Re: Docket No. 70-3073; License No. SNM-1999
Response to Request for Additional Information
Final Status Survey Reports for Sectors 7 – 11 and Addendum for Sector 6

TECHNICAL MEMORANDUM 05-13

Subject: *Response to NRC Comments on Cushing Sectors 6-11 Final Status Survey Reports (FSSR)*

UDA Expansion Grids Near B072E29S21

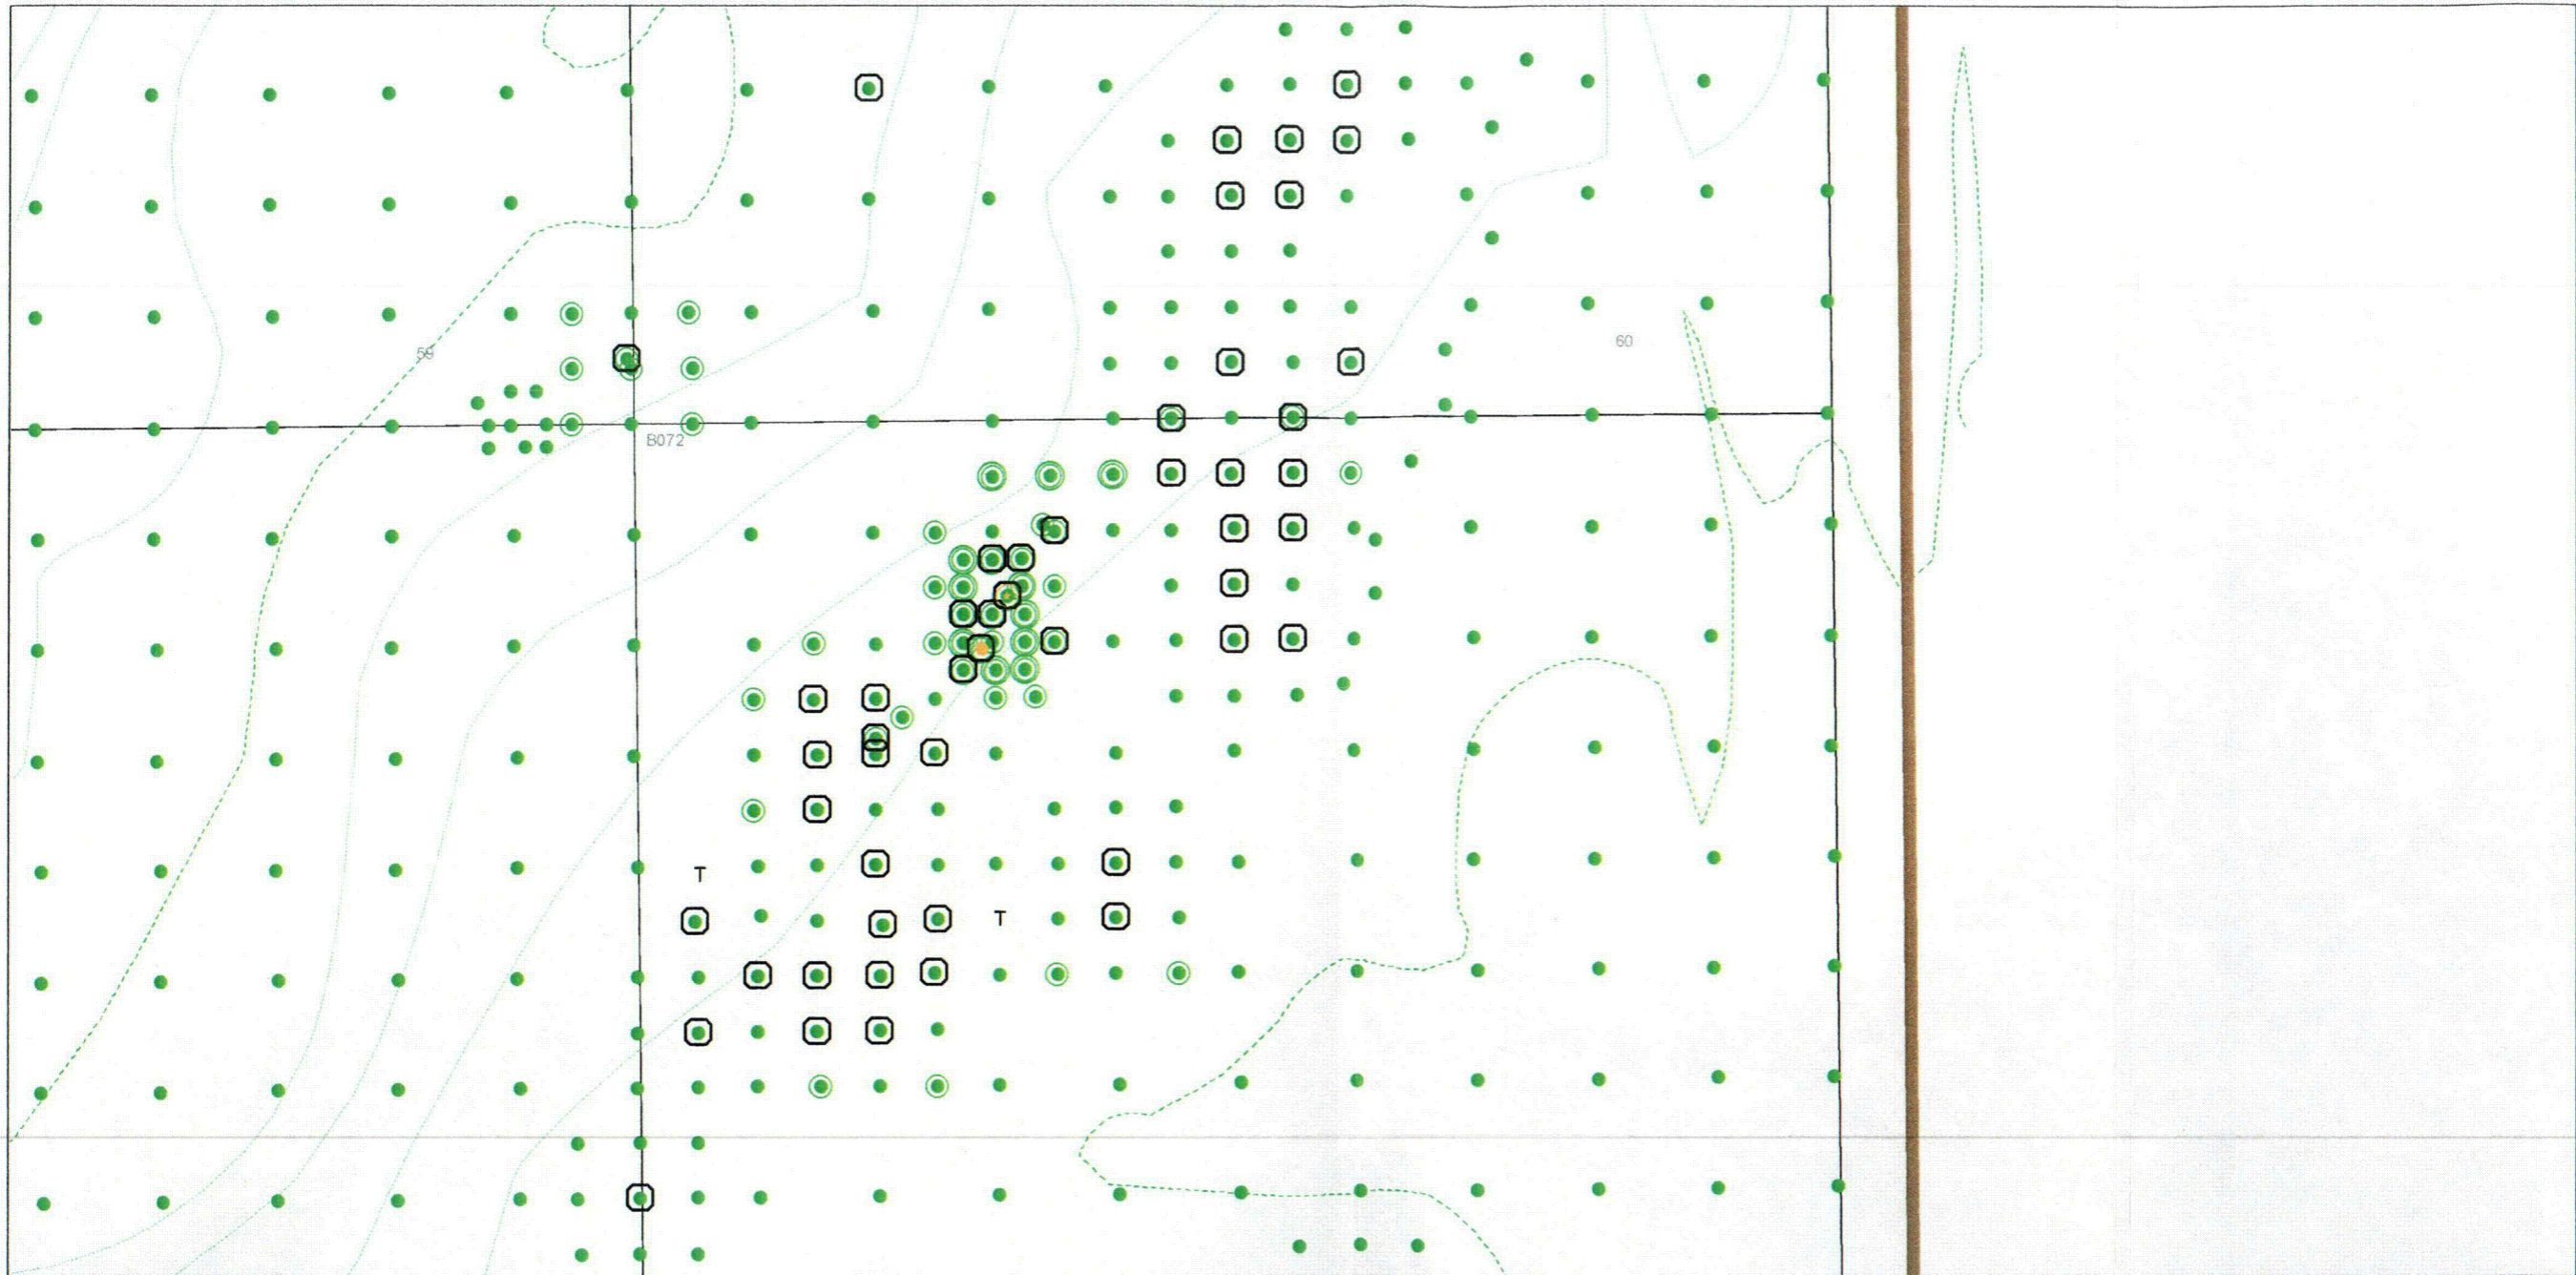
- 4.1.1 *Section 4.1.3.3, page 21: The section discusses the identification of two soil samples exceeding the fraction of the maximum permissible concentration (FMPC). The document does not indicate whether these locations were identified for sampling as a result of surface scans—Sections 4.2.4 or 4.2.5 do not specifically provide this information—or from the systematic sampling. This is relevant to confirmation of the surface scan Minimum Detectable Concentrations (MDCs). Furthermore, the reviewer interprets that these samples were collected from Survey Unit 808 which is listed as an undesignated area in Table 2.1 on page 6. With the identification of residual activity in excess of the FMPC, was this survey unit, or portions thereof, reclassified as affected?*

- 4.2.1 As part of the requirements for soil characterization, any samples taken in undesignated areas (UDA) which showed activity exceeding 0.25 FMPC were enclosed by a 5 meter grid of soil samples. In addition, they were rescanned by hand, and soil samples were collected at local maxima even when these did not exceed the scan threshold. By tightening the grid to 5 meters, areas containing soil samples exceeding 0.25 FMPC in UDAs were treated as affected areas although they were not specifically labeled as such. Soil samples above 0.25 FMPC in the northeast corner of Sector 8 are shown with decreased (5m) grid spacing in Attachment B as they were reported in the Sector 8 Characterization Report.

- 4.2.3 The soil samples at locations B072E29S21 and B072E31S16 were both identified by the rescan of these areas as mentioned above. The sample at location B072E29S21 was obtained on the surface, while the sample at B072E31S16 is a 0.5 – 1.0 ft depth sample. Two subsequent samples were collected at B072E29S21 on the surface which could not confirm the elevated surface reading obtained earlier at that location. No other samples or scans surrounding or below either of these locations showed any indication of elevated activity.
